Name: Eastgate Village Townhomes - Elm & 28 ¼ Prelim-Final

EASTGATE VILLAGE TOWNHOMES FILING 2

Review Comments: Bill Cheney, Utility Engineer, 6/13/91

EASTGATE VILLAGE TOWNHOMES FILING 2

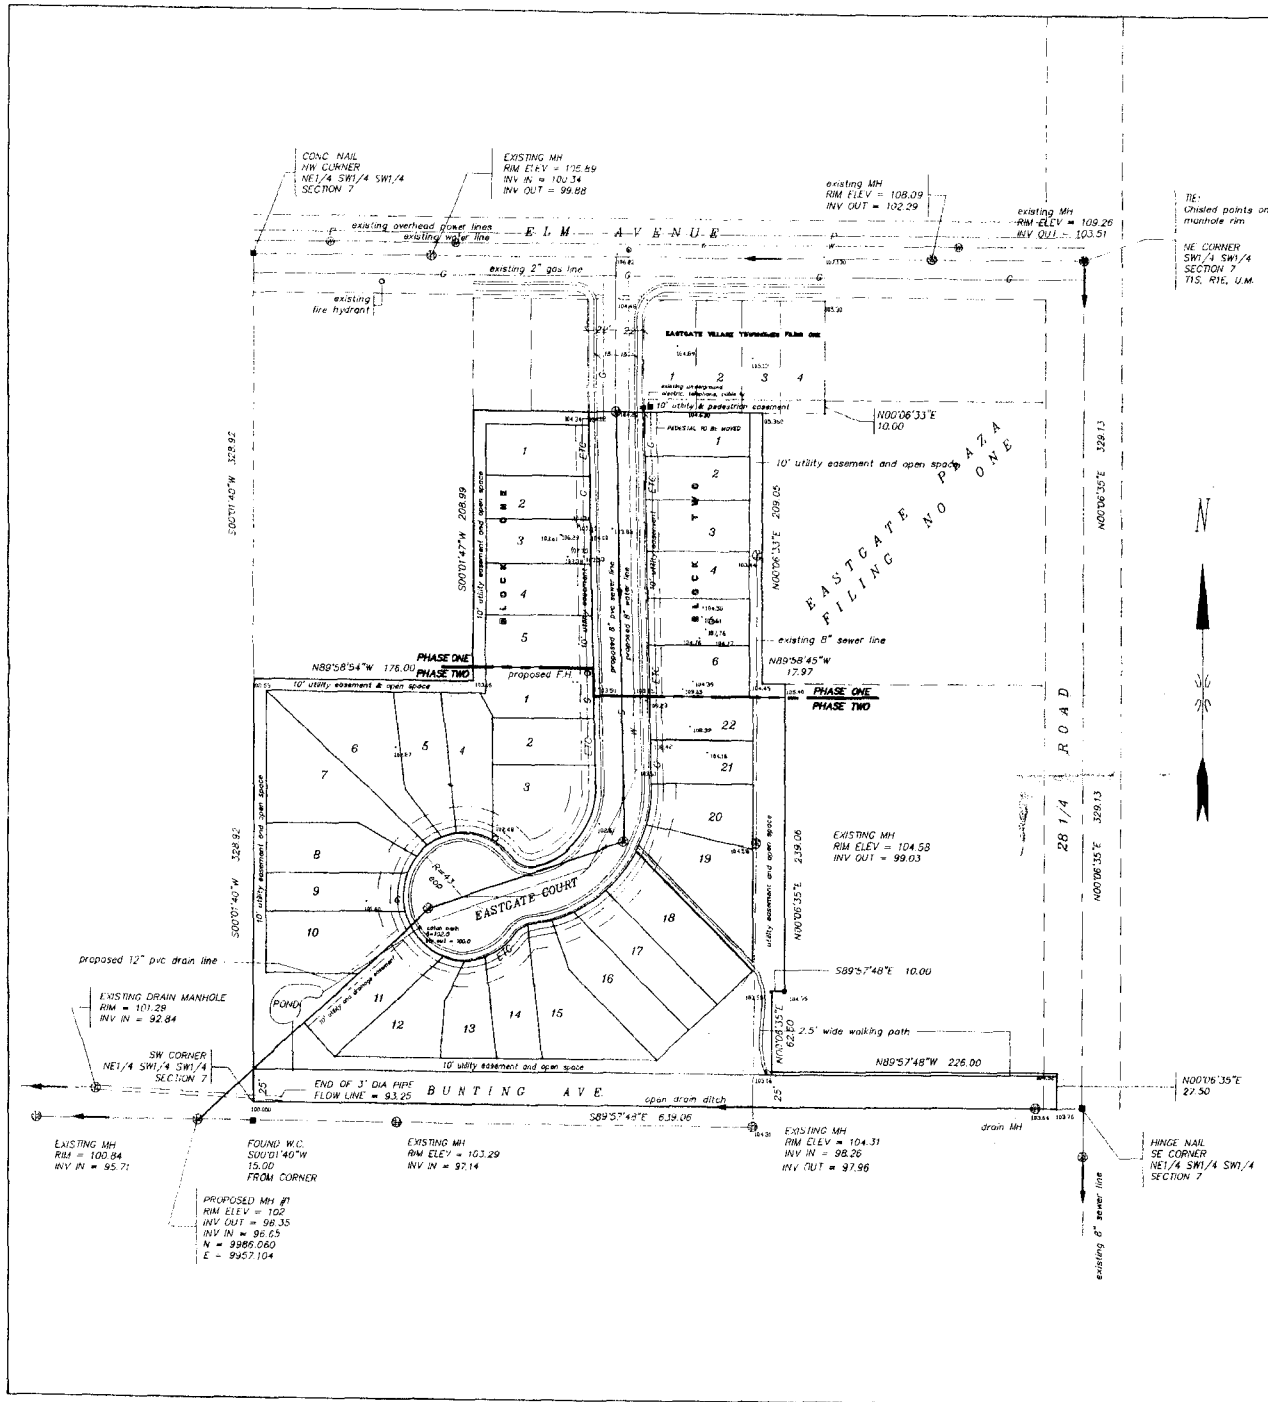
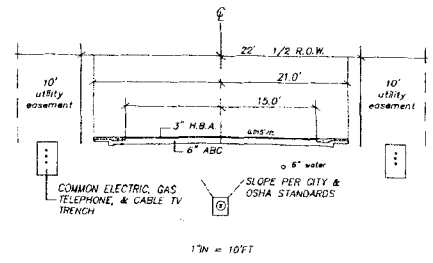
18. Where the sewer line crosses the sewer line (2 locations) the sewer line shall be encased per City Specifications. Show details of encasement on plans.
19. Label sewer line in Elm Avenue.

The following items on the "Composite Utilities and Roadway Plan" have not been adequately addressed:

- 5-6-5-A.2: Water line profiles were not included in submittal
- 5-6-5-A.4: No details for all pipe, service connections and manholes were submitted.
- 5-6-5-A.7: The plans have not been stamped or sealed by a professional engineer.
- 5-6-5-B.2: Show locations and sizes of all irrigation and drainage systems as well as any other utilities serving the development.
- 5-6-5-B.3: Show location of all street lights and lamp sizes.
- 5-6-5-b.5: The plans for part B have not been stamped or sealed by a professional engineer.

2. Show encasements on the sewer line where the water line intersects the sewer line. Based on the proposed elevations for the water and sewer there could be some conflicts where they cross. This issue needs to be addressed and shown on the profiles for both sewer and water.

3. The delineation on the "Utilities Composite" for the existing water and sewer is not clear. What is the size of the water line in Elm? The sewer is shown flowing both directions at the manhole at the corner of Elm and 28 1/4 Road. Is this the case?

The "UTILITY COMPOSITE" calls out a gutter elevation of 102.0 at the catch basin in the southwest portion of the cul-de-sac, with a call for the flow line of the pipe going to the "pond" of 100.0. According to the ALL THE MANUFACTURER'S recommendations the District is familiar with for the installation of pvc drain (pipe) there is inadequate cover for the pipe. There were no detailed street plans in the package of material sent to the District for review. There were no detailed drainage plans sent to the District for review. There is no definitive information on who will own and/or operate the pond. What is the bottom of the pond to be? Will the bottom be lined, with what, if not, why not? What is to be the cleaning schedule, by whom, at whose cost?

1. Encasement of sewer/water crossings have been shown.
2. All construction dwgs will be signed & stamped by a Registered Professional Engineer.
3. City Traffic Engineer will be contacted to locate 'Dead End' & 'Stop' signs.
4. Concept design of irrigation system has been shown. This calls for line sizes, pressurization concepts, and line locations. The contractor (ie. Grand Junction Pipe, Irrigation Systems etc.) will accomplish the detail design to the engineer's approval.

1. Encasement of sewer/water crossings have been shown.
2. All construction dwgs will be signed & stamped by a Registered Professional Engineer.
3. City Traffic Engineer will be contacted to locate 'Dead End' & 'Stop' signs.
4. Concept design of irrigation system has been shown. This calls for line sizes, pressurization concepts, and line locations. The contractor (ie. Grand Junction Pipe, Irrigation Systems etc.) will accomplish the detail design to the engineer's approval.
